Aquaculture Licenses Appeals Board (ALAB)

Site Reference: T05/591A

ALAB Reference: AP45/2018

Report with respect to Navigation near Bank Harbour, Bantry Bay, Co. Cork.

Figure 3.2.2: Proposed channel in the site.

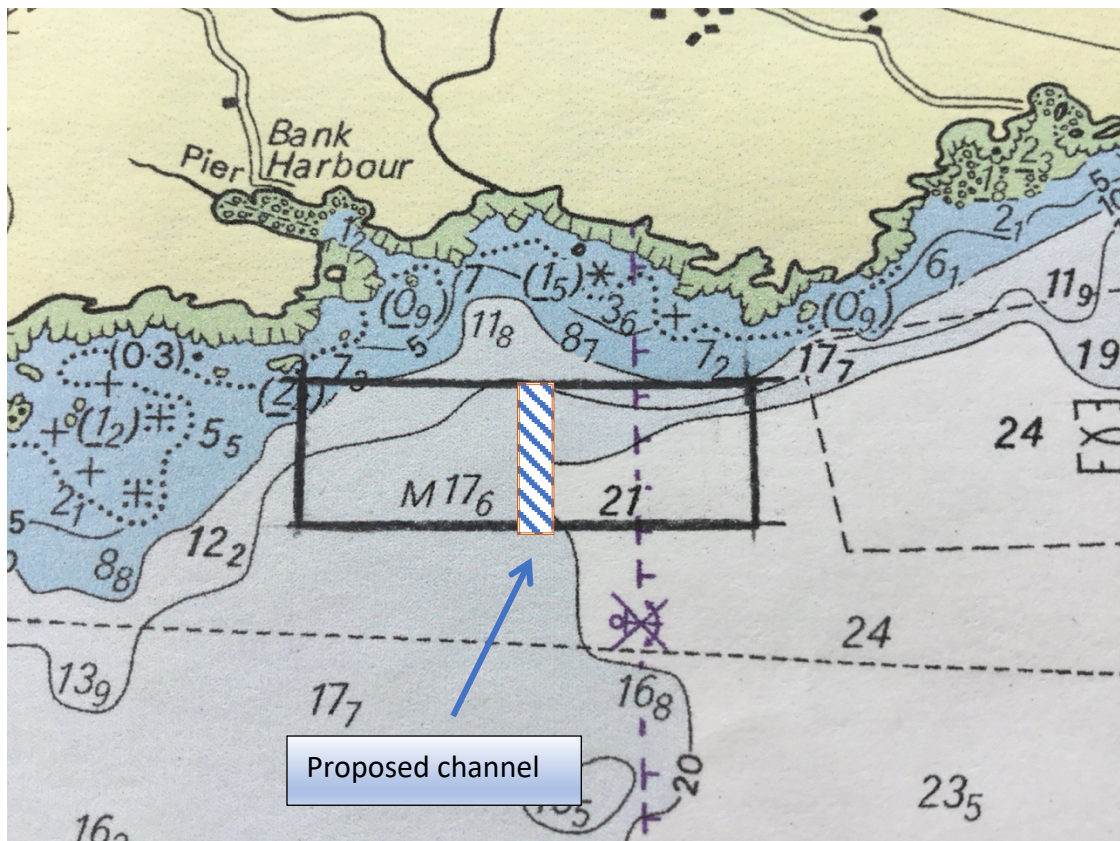
Figure 3.2.2 below shows the proposed new site with a navigation channel to allow access to and from Bank Harbour.

Figure 4.1: Overview of the proposed site and the Roancarraig site and approaches.

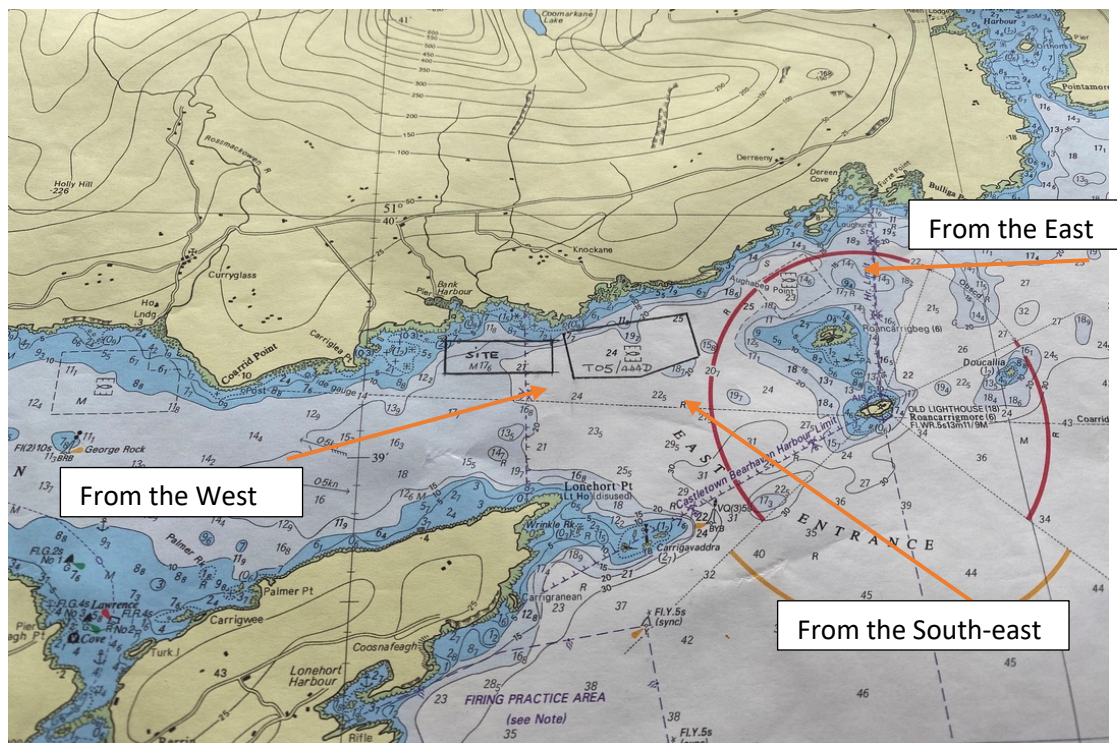
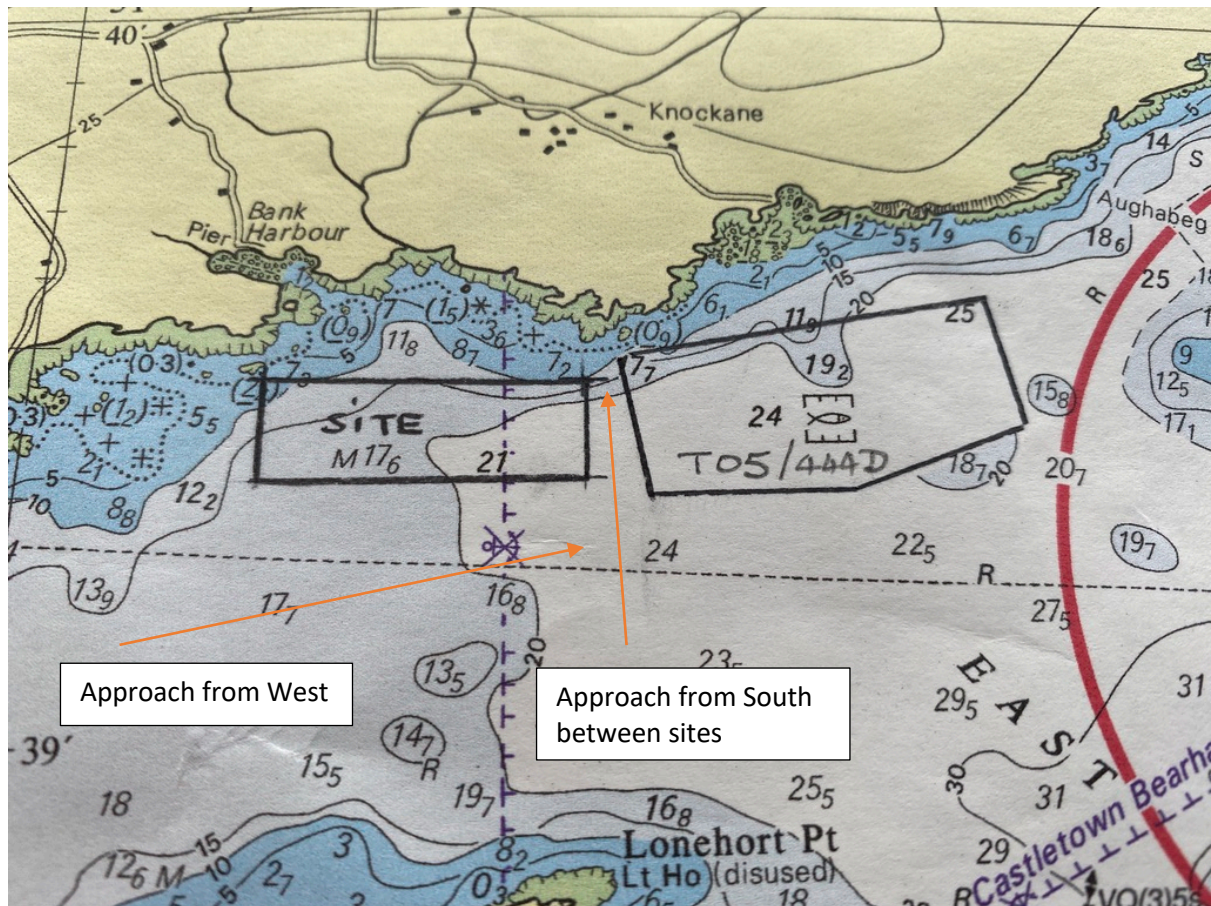
Approaches from the East would be via the East Entrance or in good weather north of Roancarrigbeg. Approaches from the West would pass north of Bere Island and south of the mainland. The orange lines on the chart show possible courses when approaching both sites. There is adequate sea-room in normal weather conditions and sufficient depth of water to allow for safe navigation to and from the sites. More detail will be shown in Figure 4.1

Figure 4.2: Approximate distances between 'pinch points'.

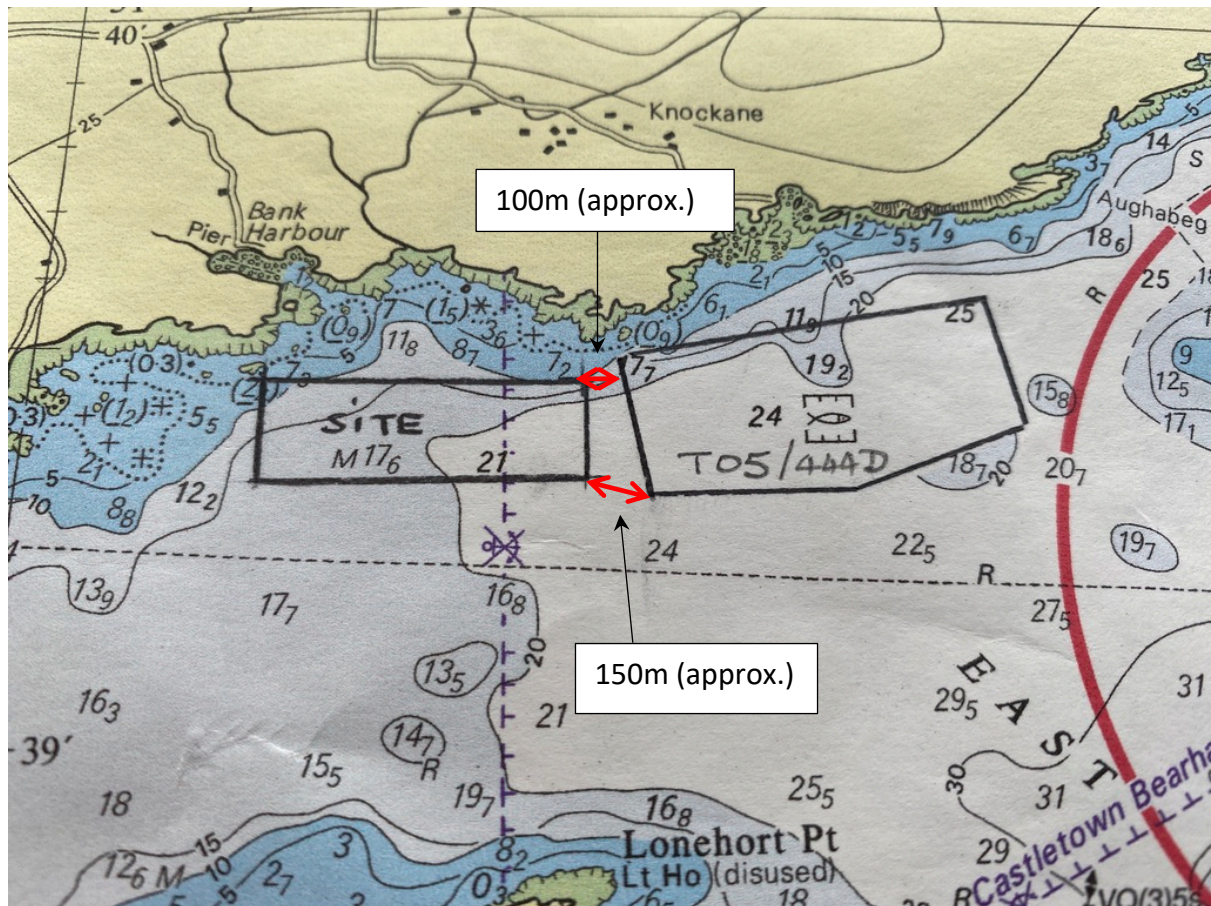
The distance between the South-east corner of the proposed site and the South-west corner of the Roancarraig site is about 150m.

The distance between the North-east corner of the proposed site and the North-west corner of the Roancarraig site is about 100m.

All of these distances are well in excess of the largest stated boat-length (60.4m) and beam (11m). Such vessels will be able to manoeuvre safely in terms of navigation when operating near the sites. The measured distances are well in excess of the entrance to Bank Harbour and Castletownbere Harbour. A comparison may be made with the main channel in the Port of Cork. That channel is 160m wide and accommodates large tankers of over 170m in length and 25m beam. Therefore, vessels of 60m in length and 11m beam will be able to manoeuvre in distances of 150m between hazards.

The above figure shows that the initial approach has a distance of approximately 150m between the southerly points and that the northerly points have a distance of approximately 100m between them.

- The location of the proposed site does not significantly affect navigation in or around the Roanarraig site.
- However, to ensure a large margin of safety, a recommended safe distance between the Roanarraig site and the proposed site should be not less than two vessel lengths, i.e. 120m.
